Questions received on 18th January 2024 with relevant answers:

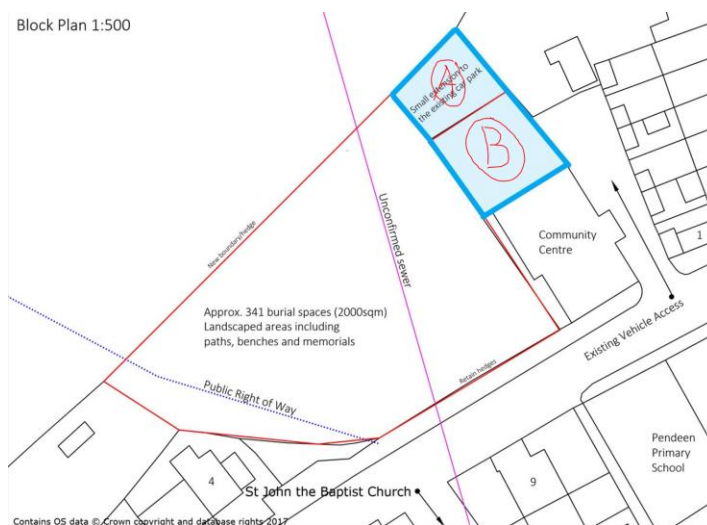
2. Can you confirm whether we need to allow for the surfacing within the whole area highlighted blue and labelled A & B below or is it just area A?

A: Tarmacking of the entire area shaded and edged in blue is required (A and B on your plan above) is required.
